UNITED STATES MARINE CORPS
MARINE CORPS BASE
CAMP LEJEUNE, NORTH CAROLINA 28542

Re: Request for Approval
Groundwater Monitoring Wells
Camp Lejeune, NC

Subject: Issuance of Variance to
Well Construction Standards
Camp Lejeune
Onslow County

Re: EPA's ltr 4 FFEA/71 of November 18, 1985

FIGURE A-1. Recommended Monitoring-Well Construction

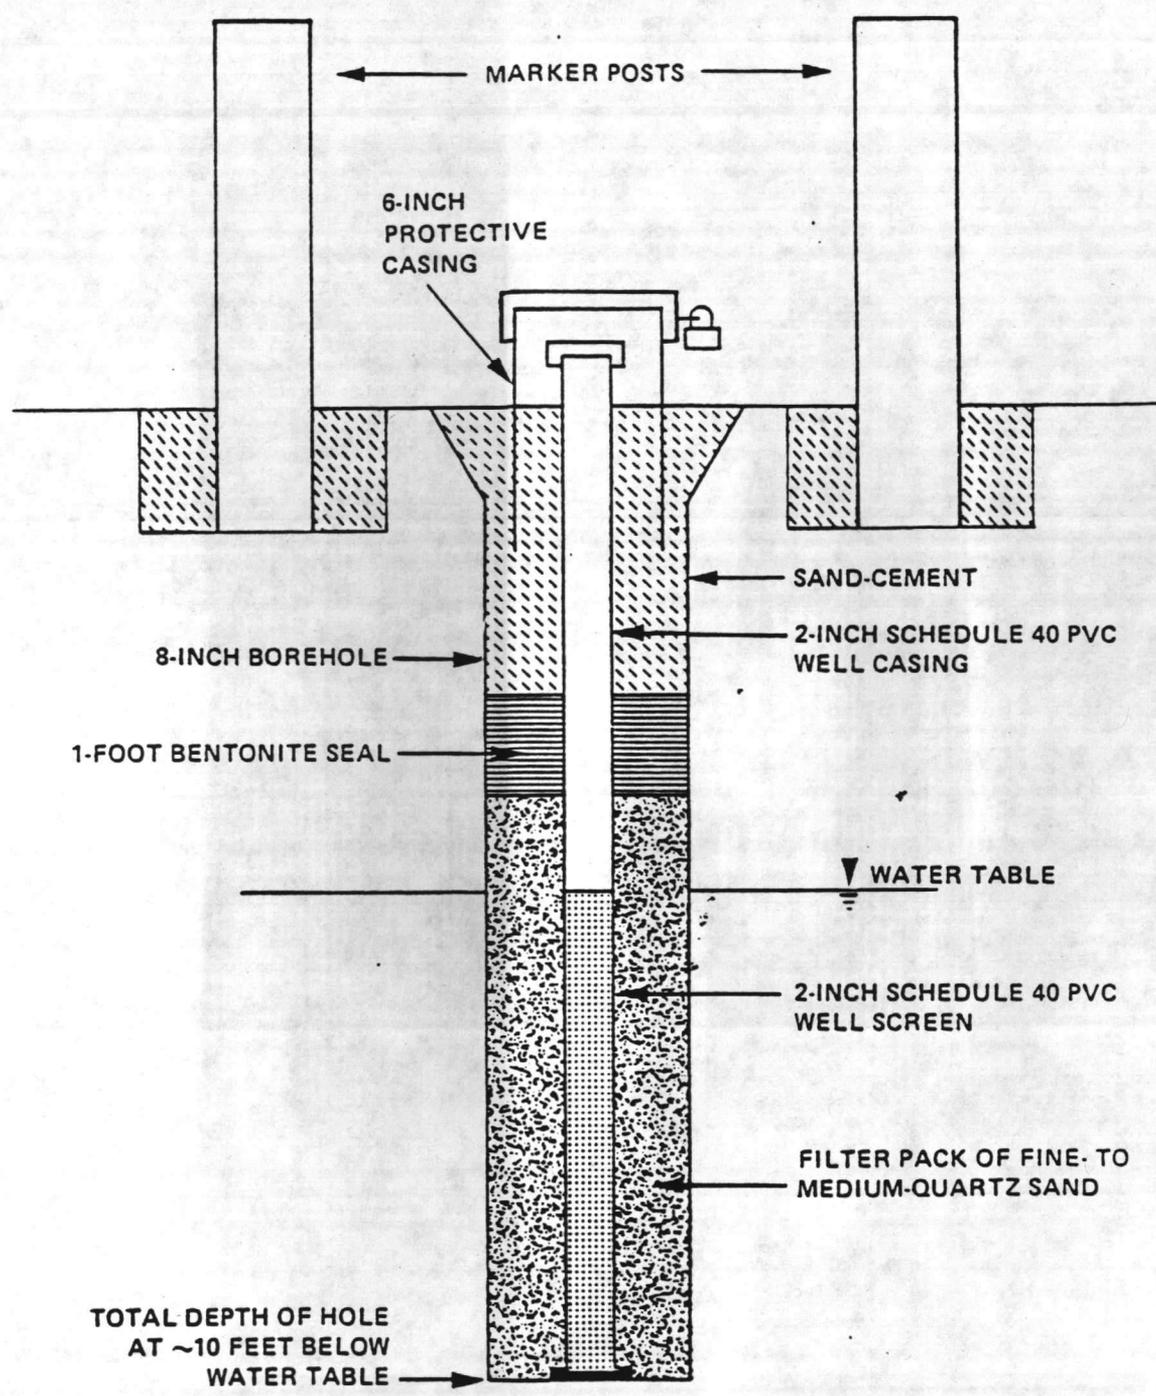
1. The wells must be located and constructed as shown in the diagrams submitted as part of the variance request.
2. The casing shall be installed in such a way as to insure the proper distribution of grout, bentonite, and gravel.
